ISO/
IEC/IEEE
8802-3

AMENDMENT 14
2022-10

**AMENDMENT 14: Bidirectional 10 Gb/s,
25 Gb/s, and 50 Gb/s optical access PHYs**

Amendment 14: Bidirectional 10 Gb/s, 25 Gb/s, and 50 Gb/s Optical Access PHYs

Figure 56–1a—Architectural positioning of EFM: higher rate P2P topologies

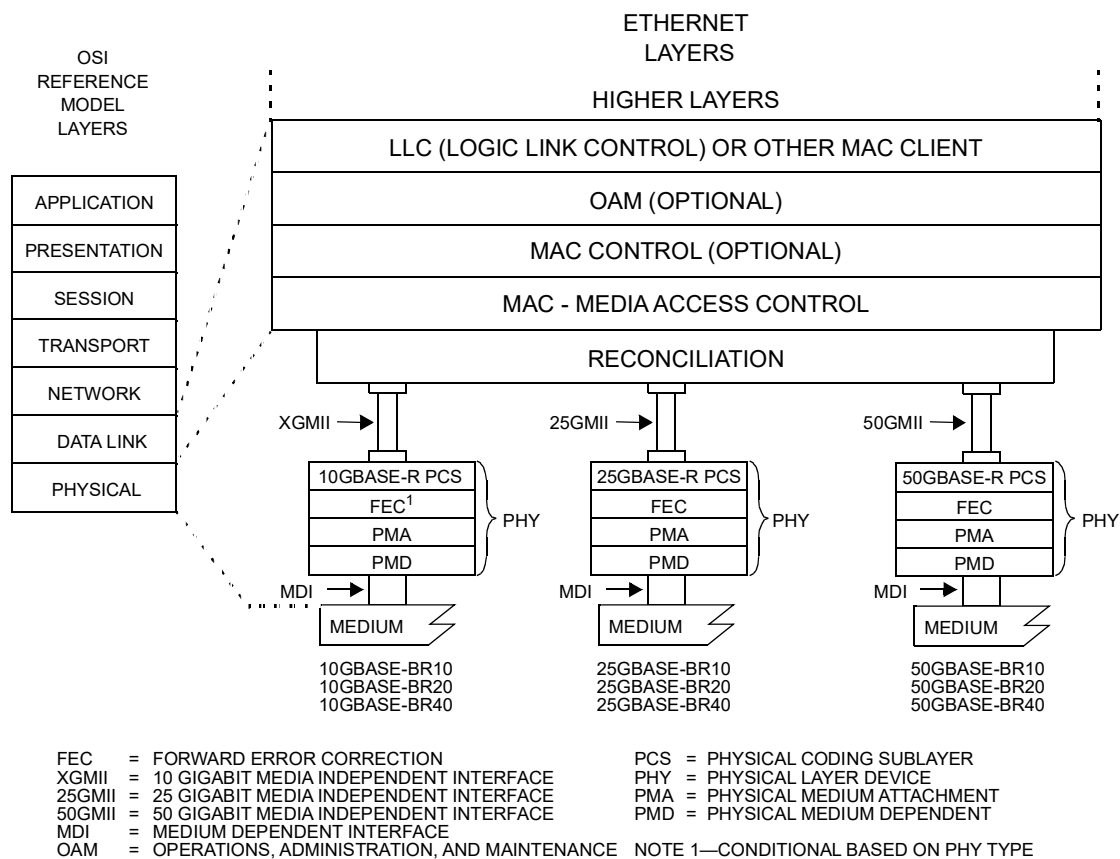
Insert new Figure 56–1a after Figure 56–1 as follows:
